CORRIGENDUM - 04 TO NIT NO-86672

Subject: Corrigendum-04 to Tender enquiry for Supply & Services of 400kV GIS for NTPC's Singrauli Tender / Project.

Project : NTPC's Singrauli Super Thermal Power Project Stage- III (2x800MW)

Project: 400kV GIS Switchyard at Singrauli Super Thermal Power Project Stage- III (2x800MW)

Drg. Title : SINGLE LINE DIAGRAM FOR SWITCHYARD

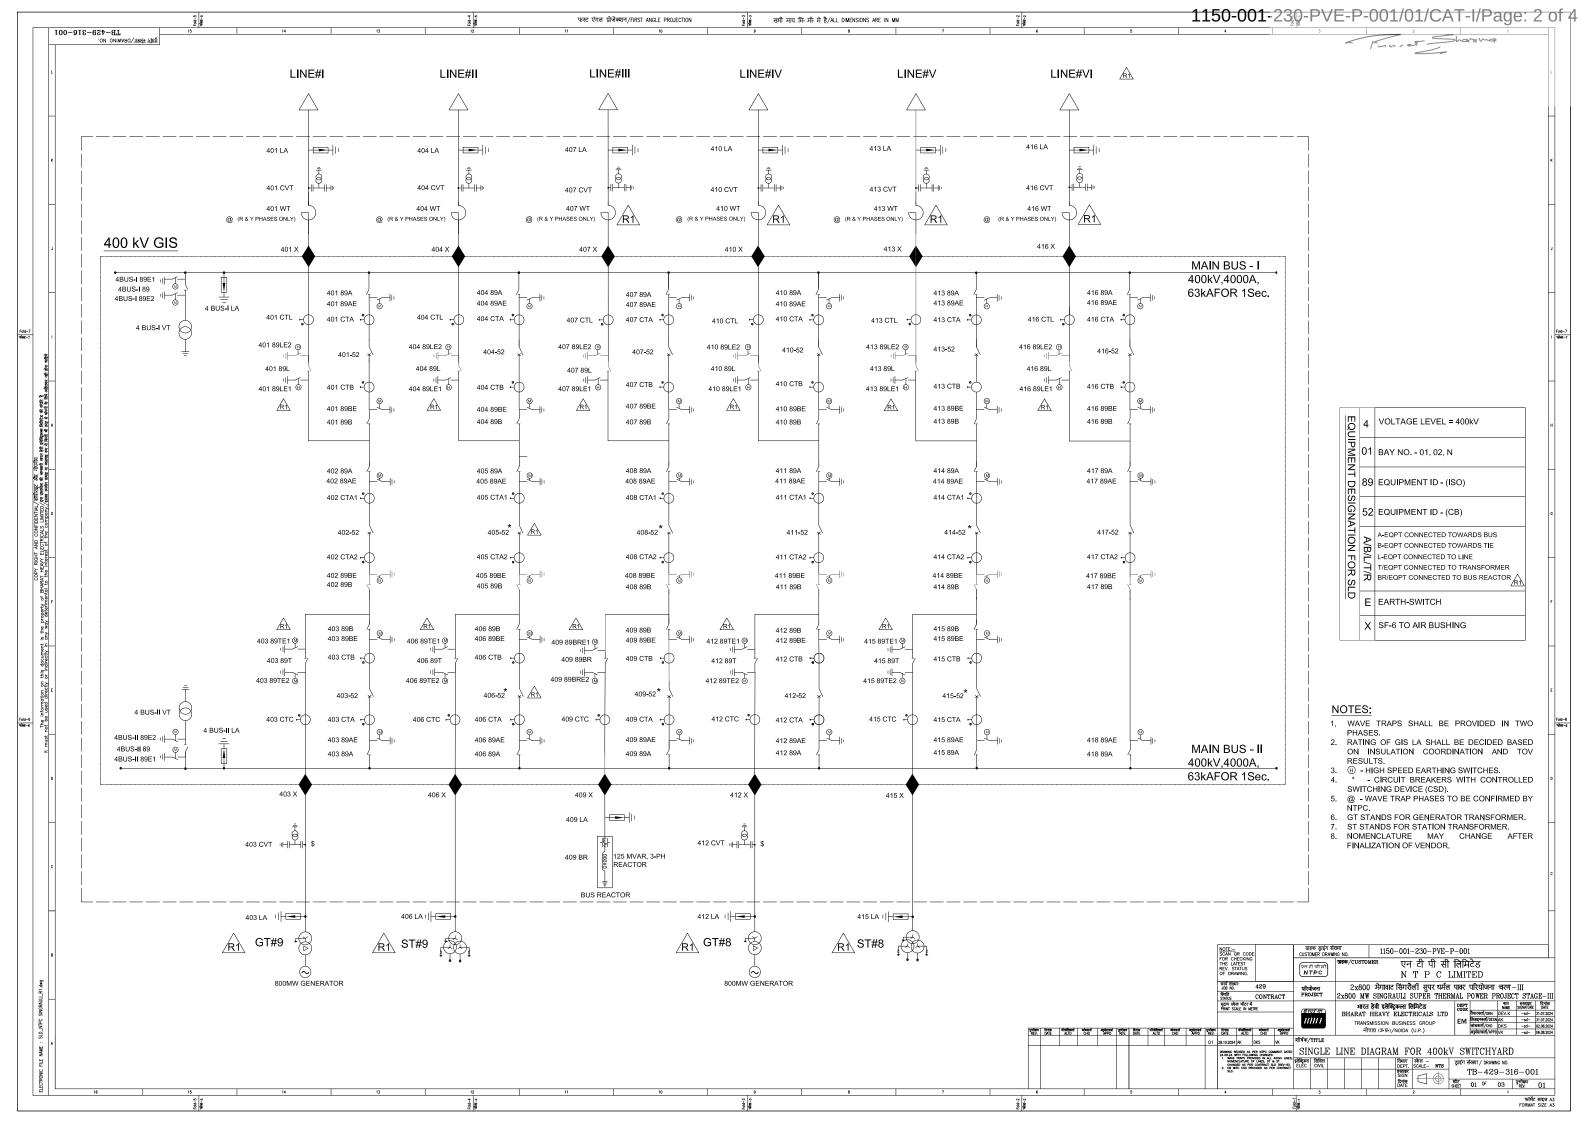
Comments

Document to be updated on finalization of transmission lines & Wavetrap details and in case

of any changes.
